St. Lucie Units 1 and 2
Docket Nos. 50-335 and 50-389

Florida Power & Light (FPL)/St. Lucie's Third Overall Integrated Plan Status Report in Response to March 12, 2012 Commission Order Modifying Licenses with Regard to Requirements for Mitigation Strategies for Beyond-Design-Basis External Events (Order Number EA-12-049)

Third Six Month Status Report for the Implementation of Order EA-12-049, Order Modifying
Licenses with Regard to Requirements for Mitigation Strategies for Beyond-Design-Basis
External Events

Figure 1 PSL FLEX Electrical Connections (Unit 1) (Rev 0A)

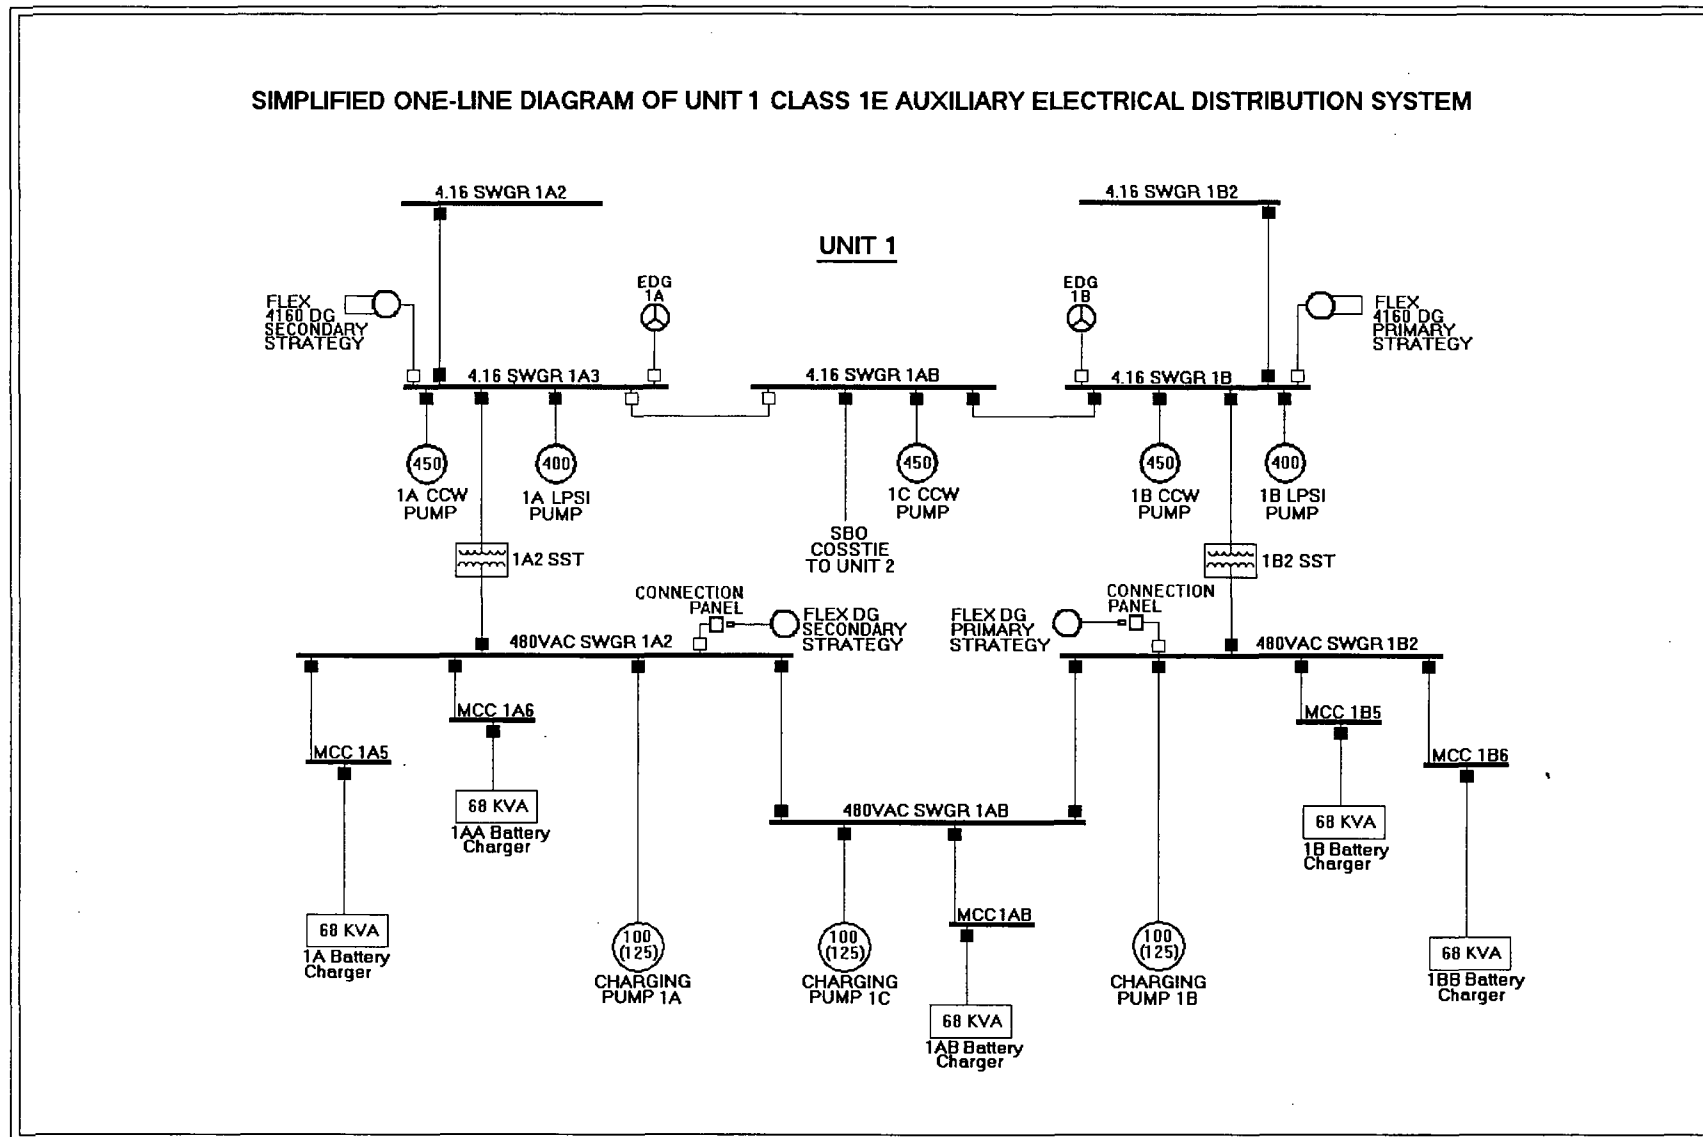
The St. Lucie FLEX strategy for making electrical system connections has evolved from that indicated in the Reference 1 response figures to be consistent with NEI 12-06 guidance (Reference 4). Refer to attached revised electrical connection figures; final versions will be provided in a future six-month update. Note the 480 volt connections will now be made using procedurally controlled breakers rather than using transfer switches.

Figure 11 Connections for CST FLEX Pump Suction on CSTs (Rev 1)

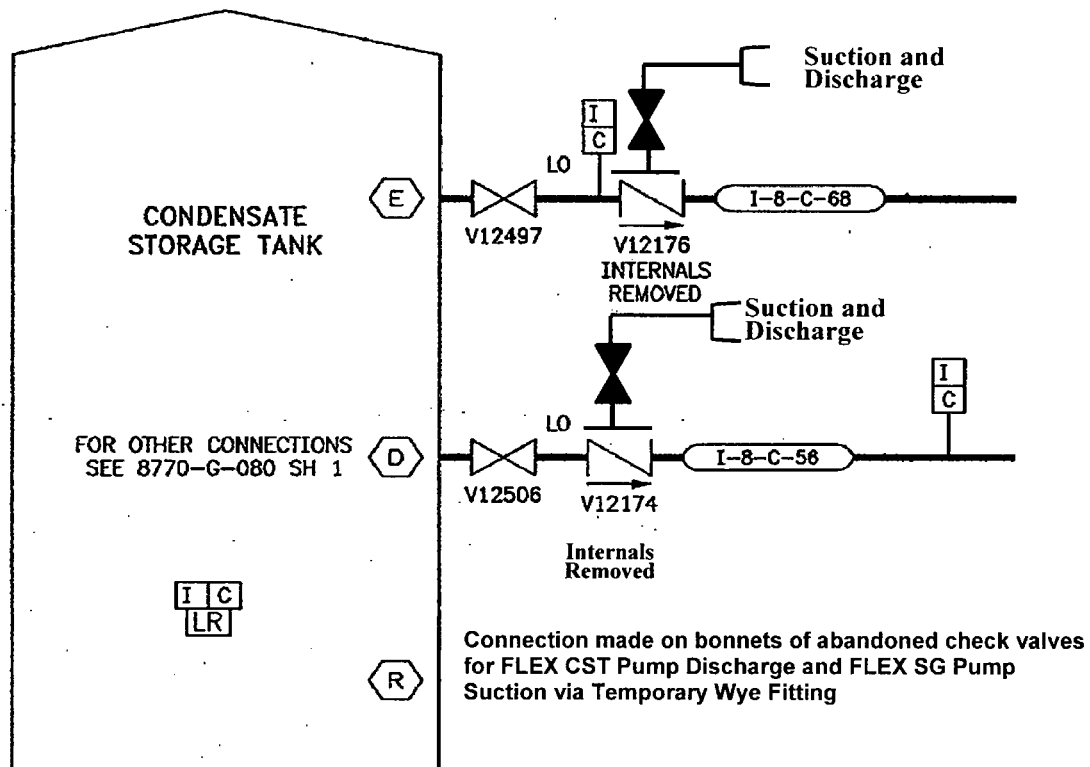
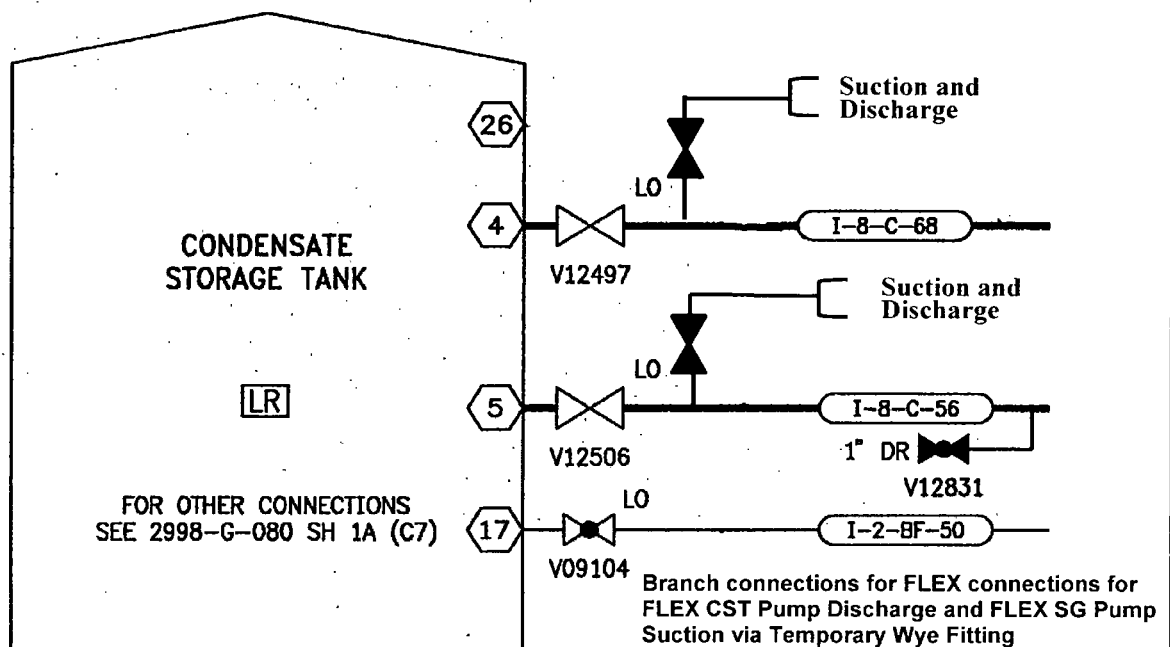
The St. Lucie FLEX strategy for making mechanical system connections has evolved from that indicated in Reference 1 response figures to be consistent with NEI 12-06 guidance (Reference 4). Secondary connections may require reconfiguration (e.g., removal of valve bonnet or disassembly of a flanged pipe joint) if validated that time and resources are reasonably available to support the reconfiguration. Location of the connection points provide reasonable assurance that at least one connection will be available for all applicable hazards. Refer to attached revised mechanical connection Figures 11, 12 and 14 for the latest changes.

Figure 13 Connections for SG FLEX Pump Discharge to AFW Pump Discharge Lines (Rev 0A)

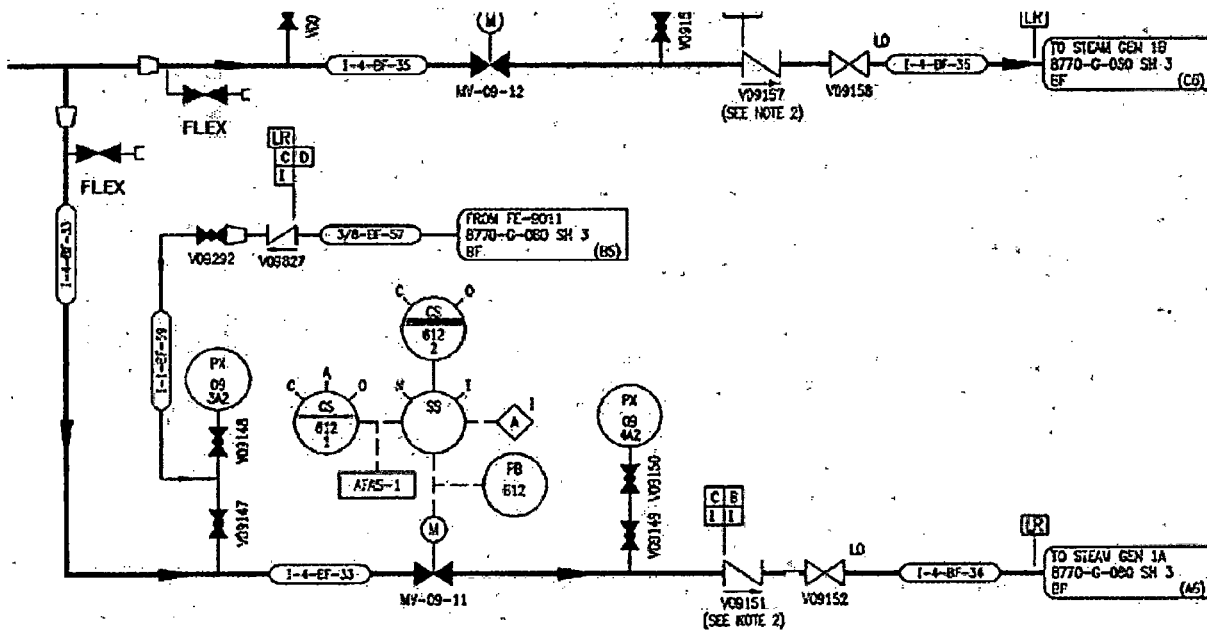
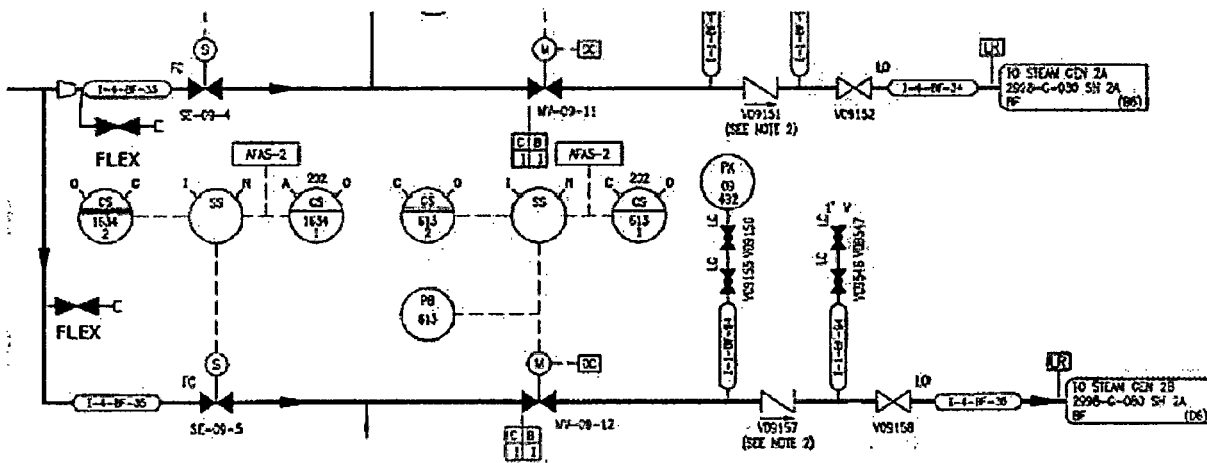
Install a 4" isolation valve and hose connection to the AFW pump 1C(2C) discharge piping for Steam Generator Injection by using a FLEX pump.

Figure 14 Connections for SG FLEX Pump Discharge to LPSI Pump Discharge Lines (Rev 1)

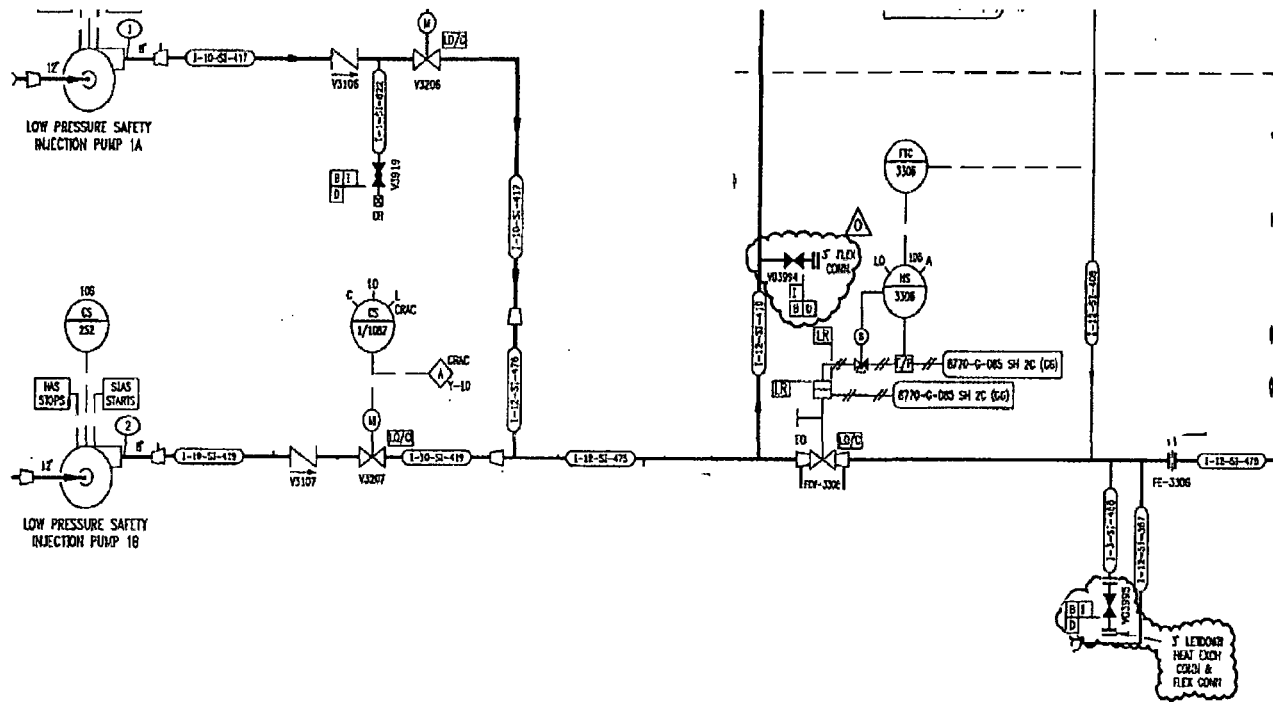
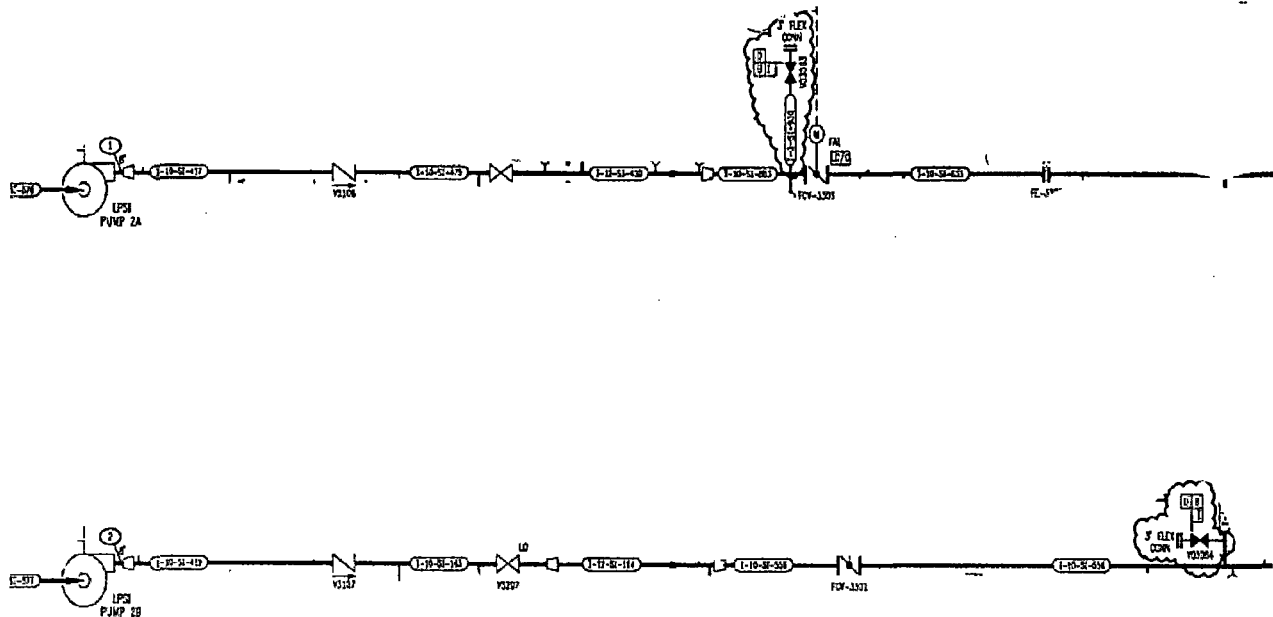
Install primary and secondary 3" isolation valves & hose connections on the LPSI 1A/1B Pumps common discharge piping. For RCS cold leg injection with FLEX SG Pump drawing suction from the RWT.

Install 3" isolation valves and hose connections on each of the LPSI 2A & 2B Pumps discharge piping. For RCS cold leg injection with FLEX SG Pump drawing suction from the RWT.

Figure 22 Connection for SFP FLEX Pump Discharge to Fuel Pool Pump (Unit 1, Unit 2 Similar) (Rev 0)

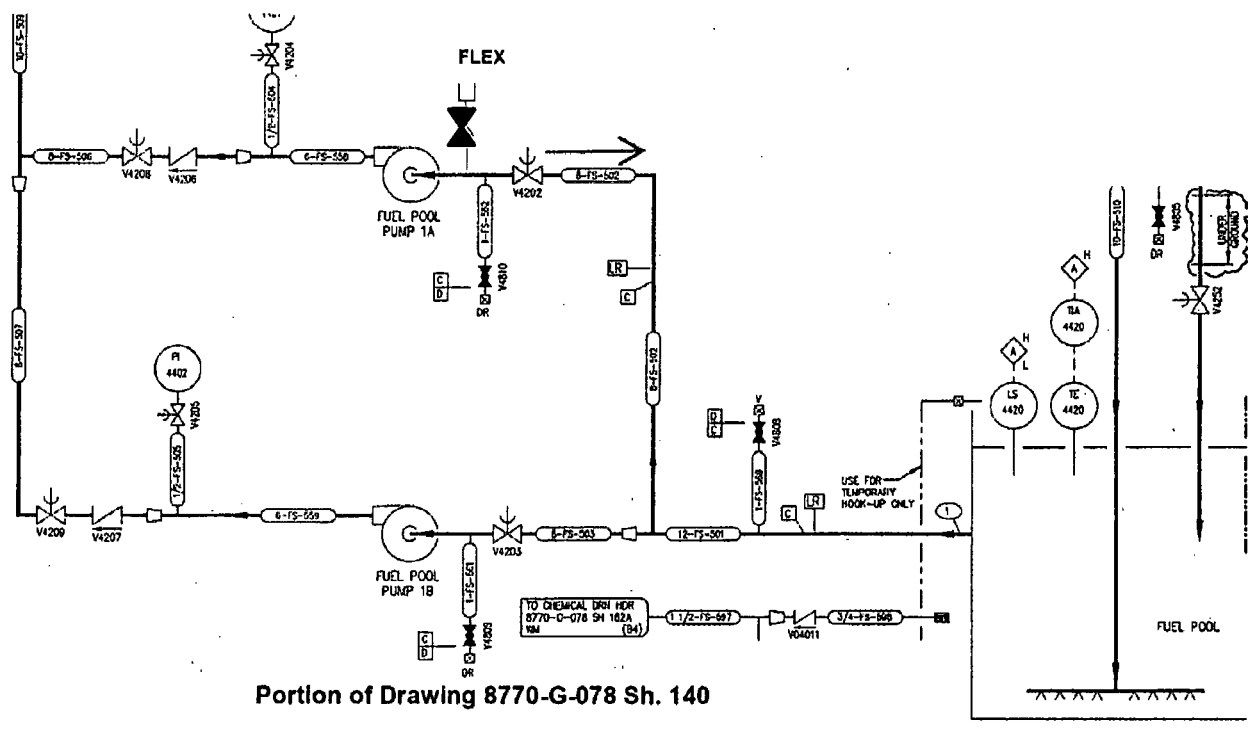
The Reference 1 FLEX response described the hardened makeup flowpath to Maintain Spent Fuel Pool Cooling as via the 2½" ICW lines on the exterior east wall of each Fuel Handling Building (FHB). In lieu of providing missile protection for these lines, an alternate missile protected flow path will be provided. The alternate path is via a new FLEX connection on the suction of one of Spent Fuel Pool Pumps on each unit. These lines and their flow paths to the Spent Fuel Pools are within the missile protected interior of the FHB's. The 2½" ICW lines remain the preferred hardpipe flowpath should they remain intact following the BDBEE. See new Figure 22.

Install a 3" isolation valve and hose connection on SFP Pumps 1A & 2A Suction piping. For SFP Hardened Makeup from FLEX SFP Pump

Figure 23 Connections for Secondary Water Sources (Ft. Pierce Utilities) for SFP FLEX Pump Suction and FLEX CST Pump Suctions (Rev. 0)

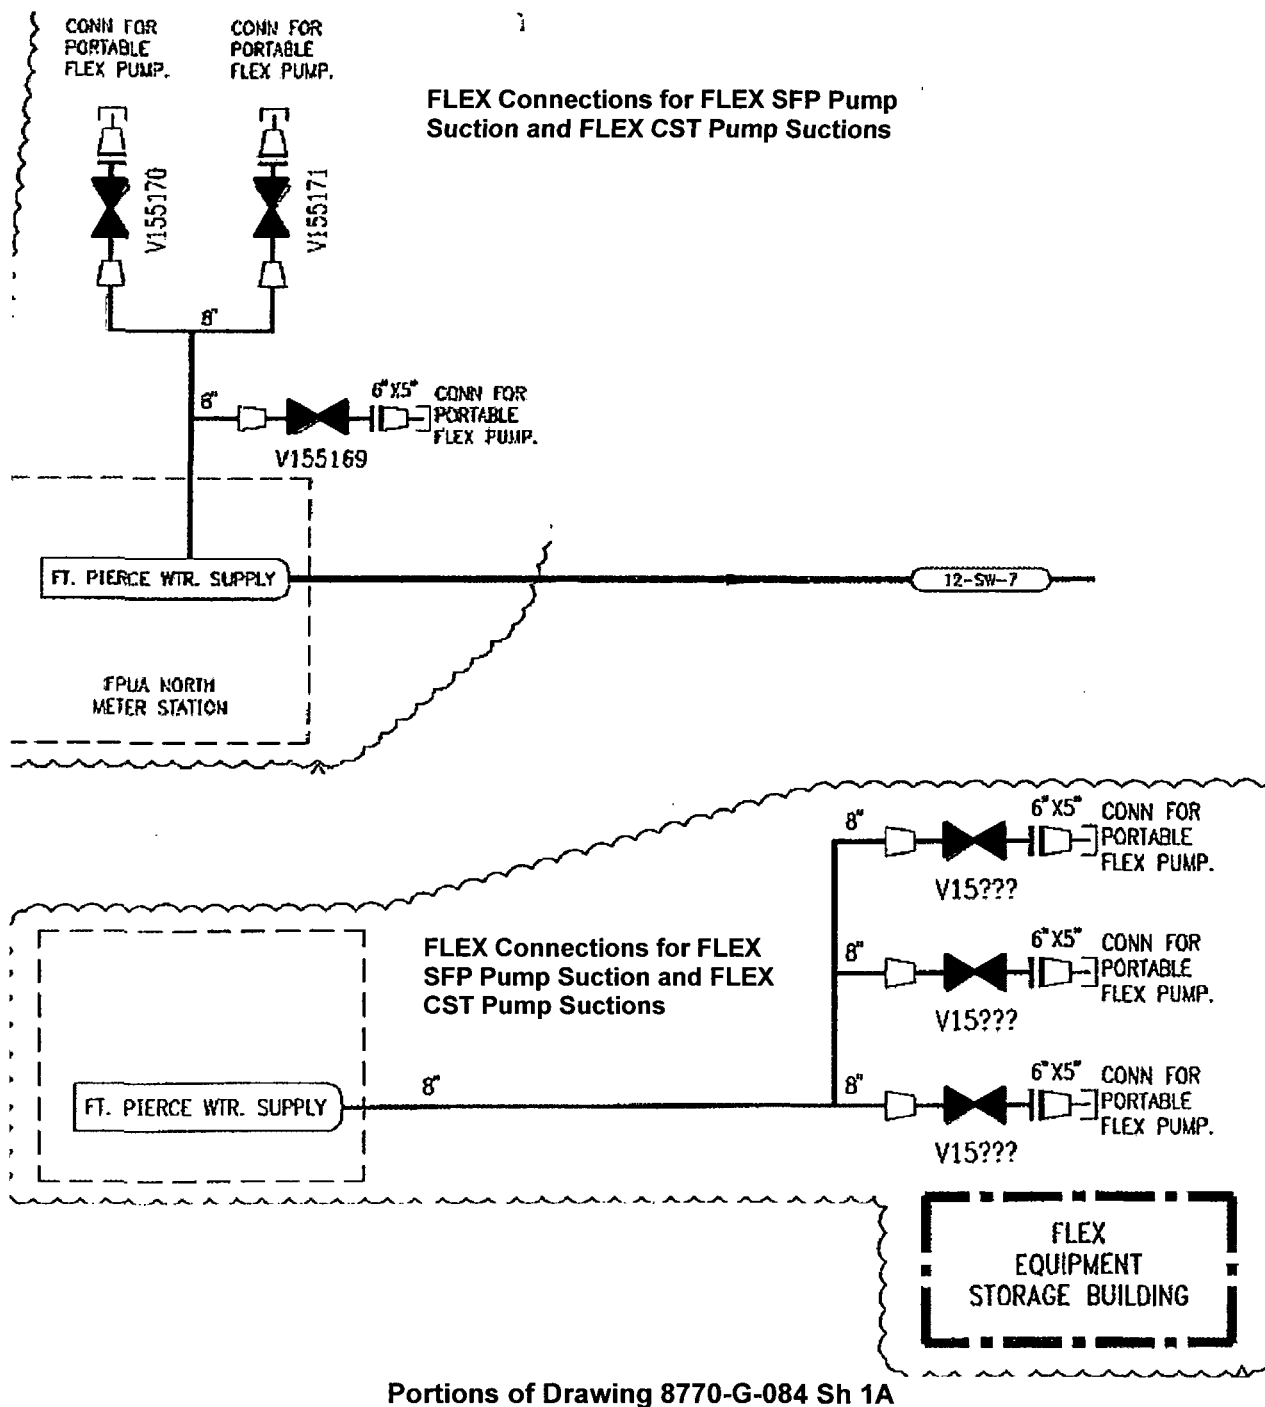
tanks will survive a high wind-tornado based event based on their design, separation and intervening structures; the CWSTs, TWST and/or PWSTs should be available as secondary sources of water to provide makeup to the CSTs/RWTs during Phase 2 following a high wind missile event. An alternate makeup water strategy credits the underground water supply line from Fort Pierce Utilities (FPU), the local potable water supplier. Rather than missile protecting the single existing source from tornado, a second source will be installed and separated by greater than diameter of typical tornado path (1200 ft) with that path oriented from the west to southwest. See new Figure 23.
